SUBJECT: Grand Gulf Nuclear Station
Unit 1
Docket No. 50-416
License No. NPF-29
Alternate Decay Heat Removal System
Proposed Amendment to the Operating
License (PCOL-88/17)
AECM-88/0186

System Energy Resources, Inc. (SERI) is submitting by this letter a proposed amendment to the Grand Gulf Operating License. This amendment requests changes to the Grand Gulf Unit One Technical Specifications due to the proposed addition of the Alternate Decay Heat Removal System (ADHRS).

TABLE 3.3.7.1-1
RADIATION MONITORING INSTRUMENTATION

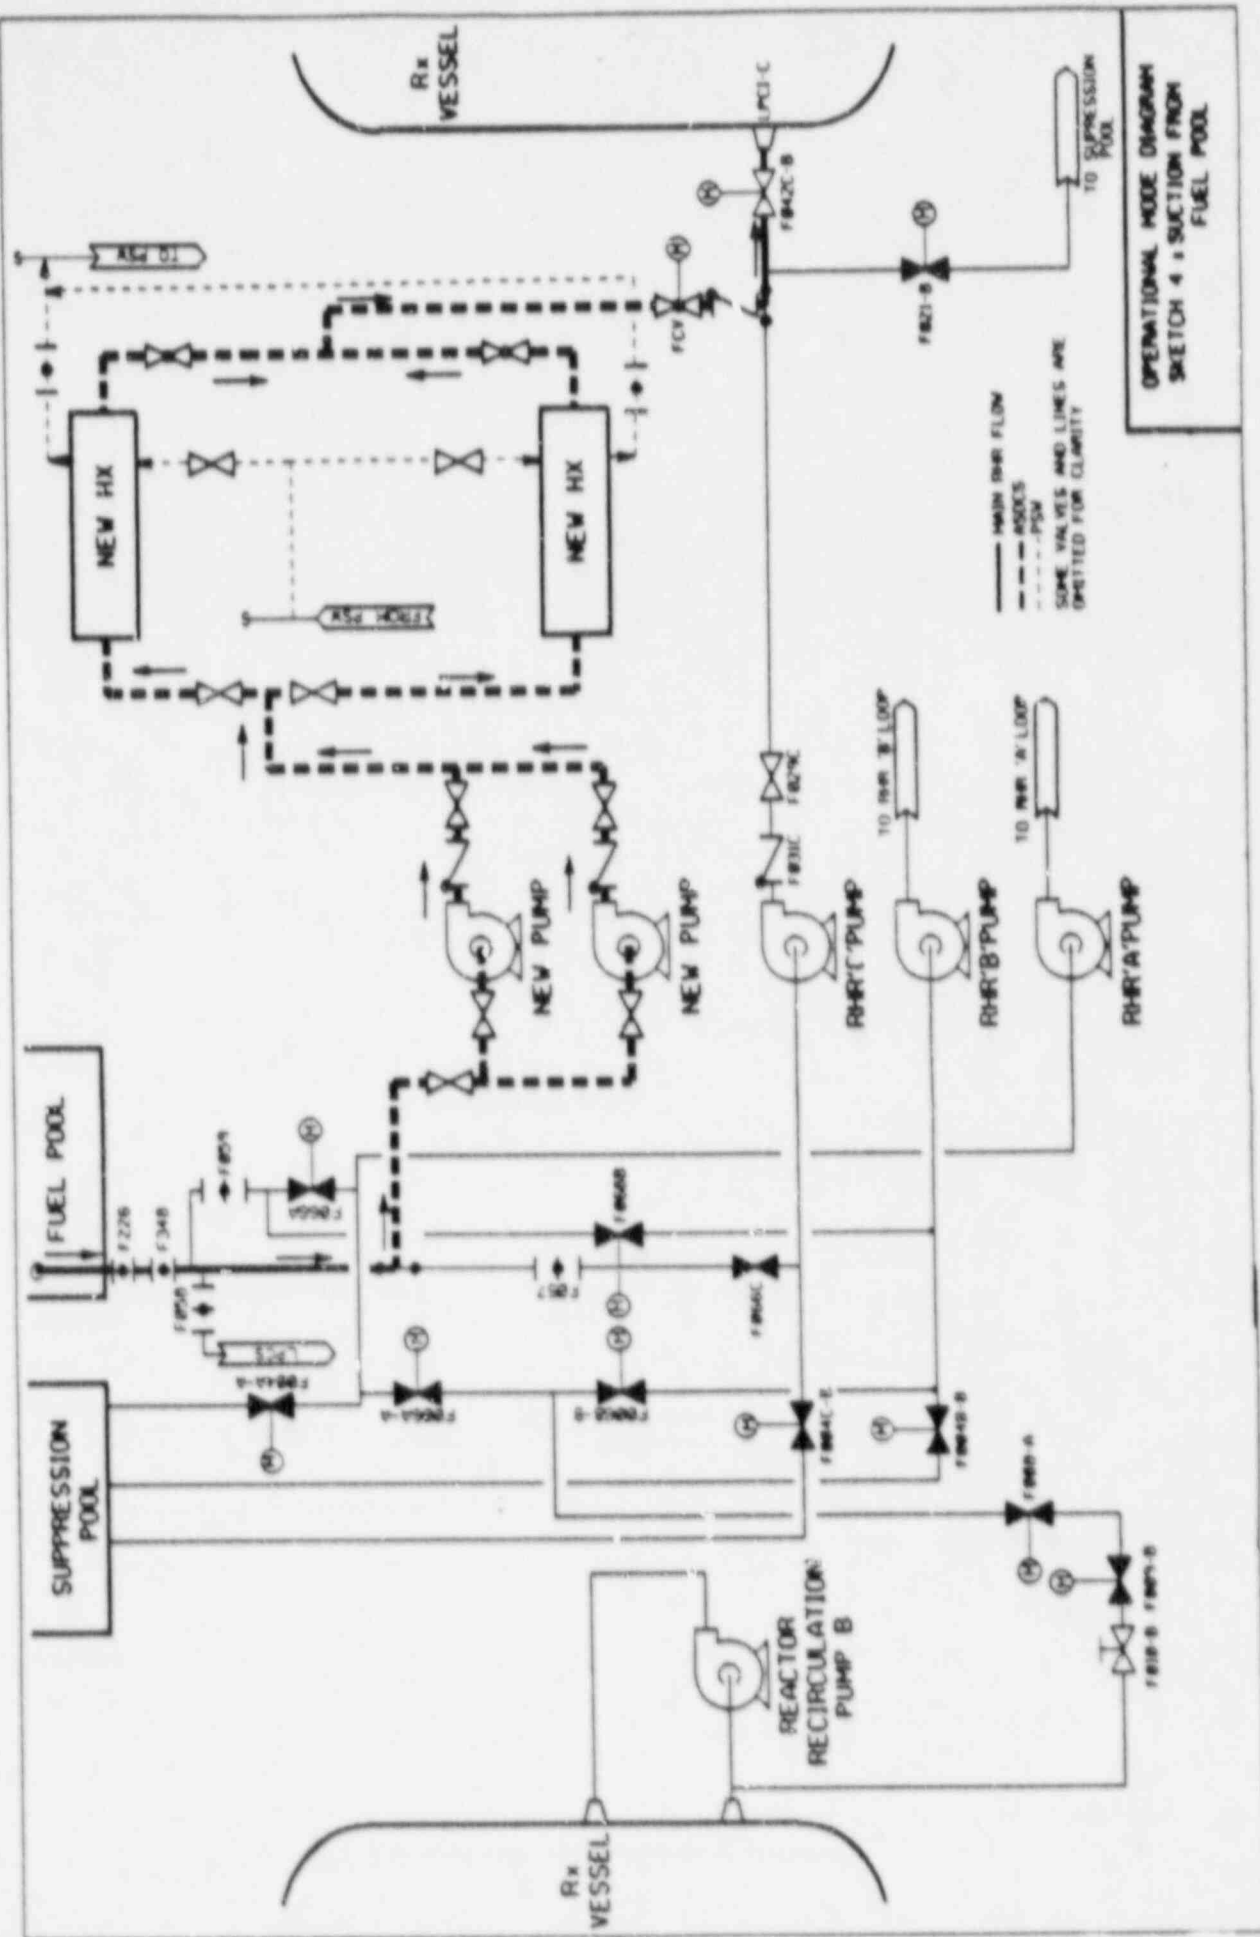
- a) The new PSW radiation monitor will be added as Item 3 of Table 3.3.7.1-1 (pg. 3/4 3-59). Only one channel will be required operable anytime the new ADHRS heat exchangers are in operation. The applicable conditions of operability will be specified using a new footnote ## which will state:

Surveillance requirements for the new PSW radiation monitor will be added as item 3 of Table 4.3.7.1-1 (pg. 3/4 3-62). The surveillance requirements will be identical to those of the CCW and the SSW radiation monitors. A channel check frequency of 'S' (i.e., at least once per 12 hours) will be

- b) The new thermal overload protection devices for valves E12F066A and E12F066B will be added to Table 3.8.4.2-1 (pg. 3/4 8-48) and included with the other RHR system thermal overload devices. The bypass device column for these two new valves will read "Continuous", meaning that these thermal overload protection devices are continuously bypassed except during testing of the motor operator. The affected system column will read "RHR System".

2. Standby Service Water System Radiation Monitor	1/heat exchanger train	1, 2, 3, and*	$< 1 \times 10^5$ cpm/NA	10 to 10^6 cpm	70
Plant Service Water System Radiation Monitor	1	##	$\leq 1 \times 10^5$ cpm/NA	10 to 10^6 cpm	70

2. Standby Service Water System Radiation Monitor	S	M	A	1, 2, 3, and*
3. [DELETED] Plant Service Water System Radiation Monitor	S	M	A	#
4. [DELETED] Carbon Bed Vault Radiation Monitor	S	M	A	1, 2
